**S5933QE PCI**  
**Controller Device**  
**Summary**

**PCI S5933QE Matchmaker Device Summary  
Revision 2, November 1, 1997**

**Figure 1**

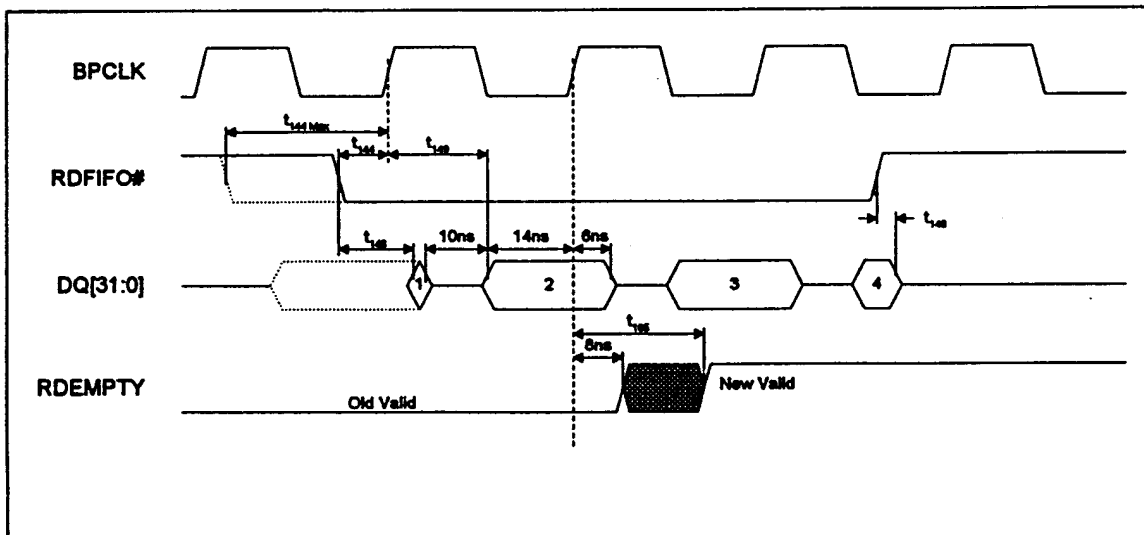
t165 page 13-11      for QC=15ns    RDEMPTY valid from BPCLK rising edge  
for QE=12ns

FIFO read: When PCI to Add-on FIFO is empty, RDEMPTY is asserted 12ns max after the rising edge of BPCLK.

As RDFIFO# requires an 8ns setup, this gives 10ns to de-assert this command before the next BPCLK edge.

**Figure 2**

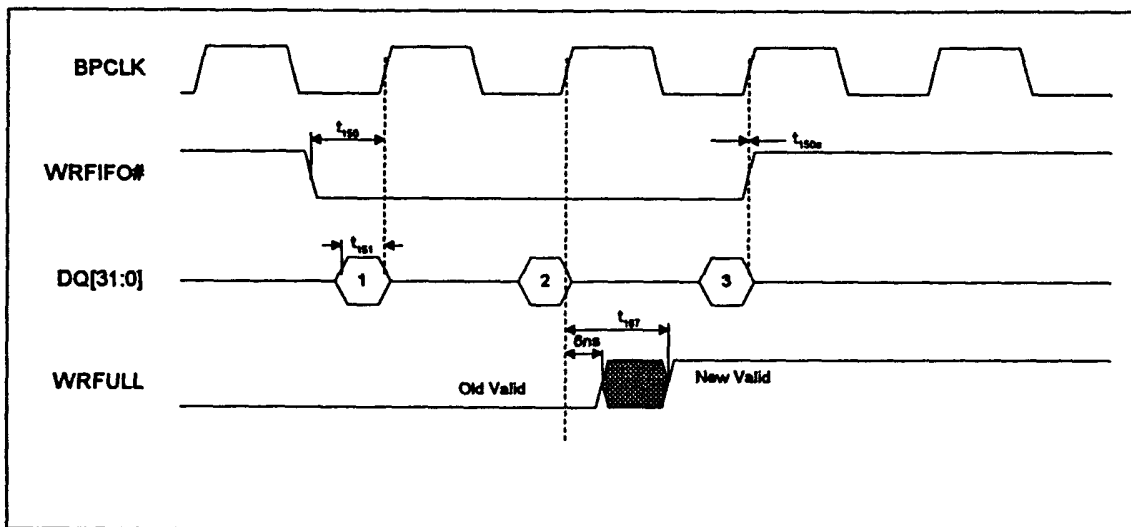
t167 page 13-12      for QC=17ns    WRFULL valid from BPCLK rising edge  
for QE=11ns

FIFO write: When the Add-on to PCI FIFO is full, WRFULL is asserted 11ns max after the rising edge of BPCLK.

As WRFIFO# requires a 12ns setup, this gives 7ns to de-assert this command before the next BPCLK edge.
